STATE OF WASHINGTON
DEPARTMENT OF ECOLOGY

RE: **Capital Industries Site #11598755**
Remedial Investigation Agreed Order
Remedial Investigation: First Phase Report

Capital Industries First Phase Report Comments

FIGURE 1

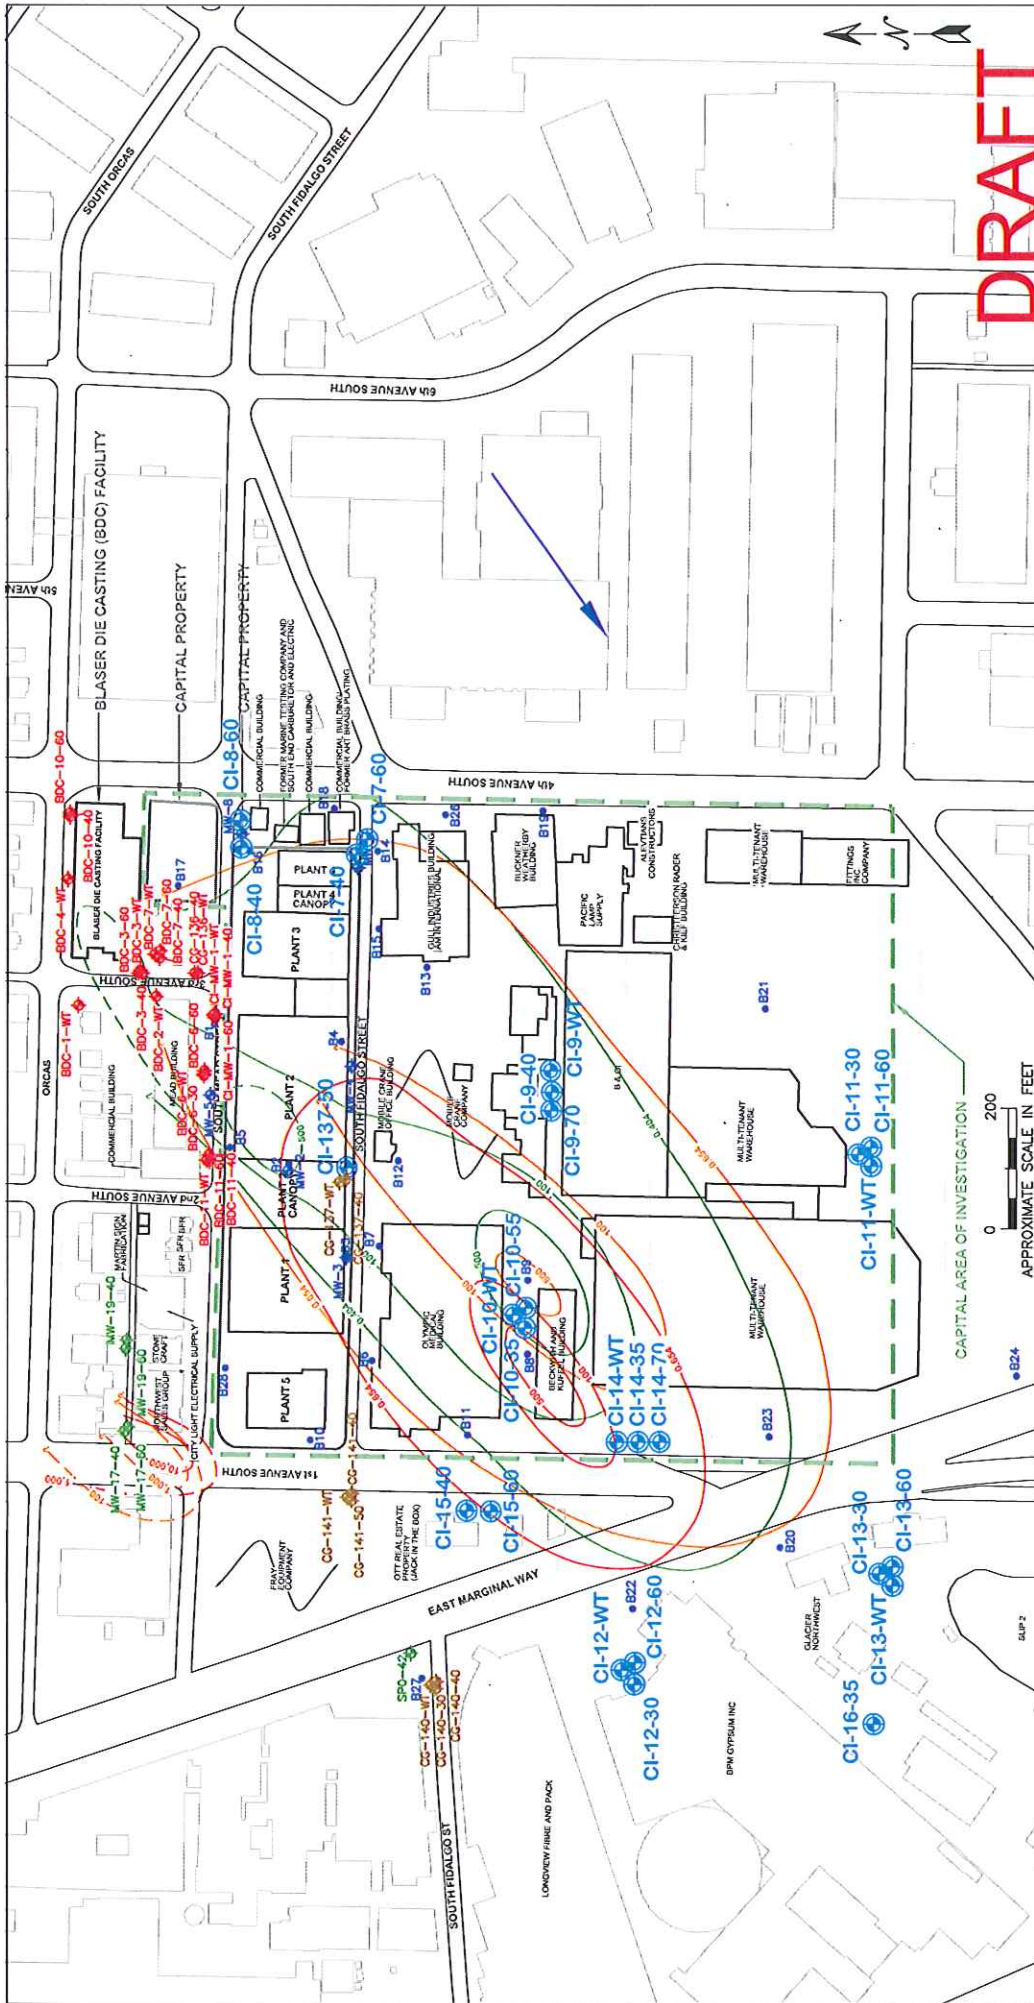
- CI-9 Cluster – The original CI-9 was proposed near direct push (DP) location B-19 to bound the Plant 4 plume; however, Ecology determined that this well cluster is not necessary and would better serve the objectives of the investigation at a point downgradient of DP point B13. The revised CI-9 location would provide analytical and hydraulic data downgradient of Plant 4. The revised CI-9 cluster may be installed either north or south of the buildings in the mobile crane company yard based on access negotiations.

- CI-10 Cluster – Ecology proposed an additional and fourth well be installed at the CI-10 cluster and screened within the shallow zone. However, Capital has revised the screen intervals to include a shallow well zoned from 25 to 35 feet below ground surface (bgs) and intermediate well zoned from 45 to 55 feet bgs instead of installing a fourth monitoring well.

- CI-12 Cluster – Ecology proposed Capital modify the location of the CI-12 cluster to a location 100 to 150 feet south of the originally proposed location. Capital will comply with this request.

- CI-13 Cluster – Ecology proposed Capital install a monitoring well cluster downgradient of DP location B23 and modify the location of the CI-13 cluster to a point approximately 250 feet southwest. To satisfy Ecology's monitoring requirements in this area, the CI-13 cluster has been modified to a location approximately 200 feet southeast of the originally proposed location. One additional monitoring well, CI-16-35, has been proposed south of the BPM Gypsum building at the request of Ecology.

- CI-14 Cluster - Ecology proposed Capital install an additional well cluster near the intersection of East Marginal Way and 1st Avenue South to define subsurface conditions downgradient of B8 and B9. Capital will comply with this request.

- CI-15 Cluster – Ecology proposed installation of shallow and intermediate zone monitoring wells downgradient of DP point B11. Capital will comply with this request by installing the CI-15 cluster on the southern portion of the Ott Real Estate Property.
